Technical comments on the proposal on Eco-design and Energy label requirements
for boilers – ENER Lot 1
June 2011

Brussels, 16 June 2011

Figure 2: comparison of installer label and bin method according to prEN 14825 of a 32kW boiler (etas 94%) with a 8kW heatpump

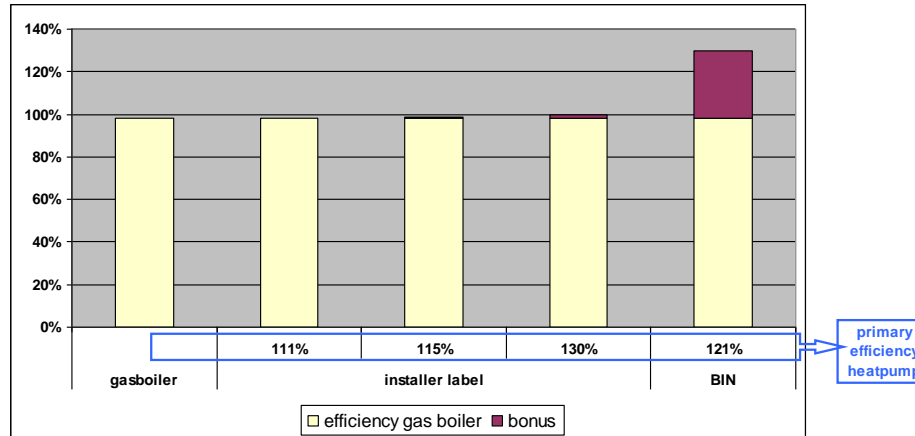
Next to it, the calculation in the product fiche underestimates the bonus that can be achieved by adding a heat pump compared to a detailed bin calculation according to prEN 14825 and should be modified accordingly.

Figure 3: BIN of a combination of a 32kW gasboiler with a 8kW heatpump at design load of 15kW with bivalent temperature at 2°C.

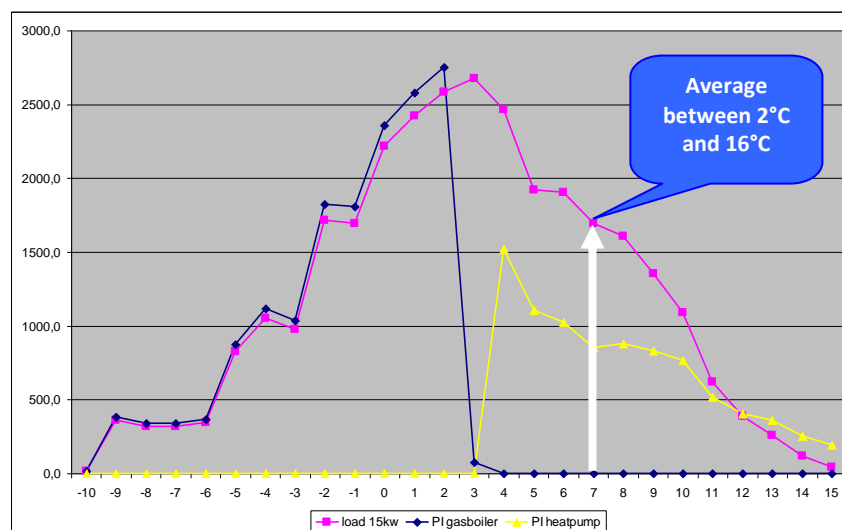
1. The assumption is made that the hybrid system will rely on the fossil fuel boiler below 2°C ambient temperature, and the heat pump will operate above 2°C ambient onwards. Usually a big fossil fuel boiler will be supported by a small heat pump. The load will be lower than the maximum capacity of the fossil fuel boiler. In this setup 60% of the load is covered by the heat pump and 40% of the load is covered by the fossil fuel boiler.

- The heat pump provides energy from 2°C to 16°C, in that area the average condition is 7°C. As such, we propose to use as hybrid coefficient of performance at 7°C. The hybrid capacity should be defined as the capacity at 2°C.

This results in following formula:

$$60\% \times (0,4 \times \boxed{\text{“hybrid” coefficient of performance}} - 1) = \boxed{\text{6}}$$

With **“hybrid heat pump coefficient of performance”** to be defined at 7°C. This implies a modification of following definition:

Figure 3: comparison of the results for present installer label, new proposal and bin method according to prEN 14825 of a 32kW boiler (etas 94%) with a 8kW heat pump

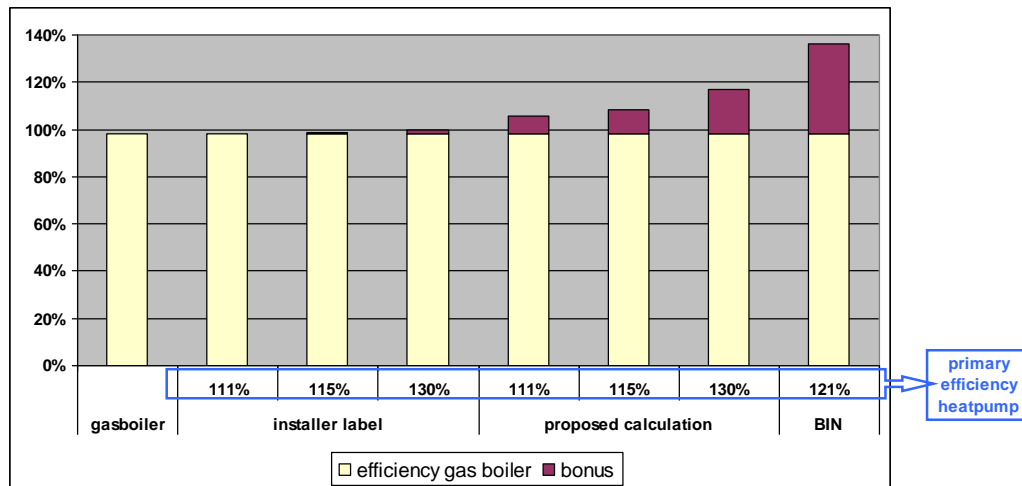
In order to validate this method, herewith you can find a comparison of the values achieved in relation to the BIN and in relation to the former method:
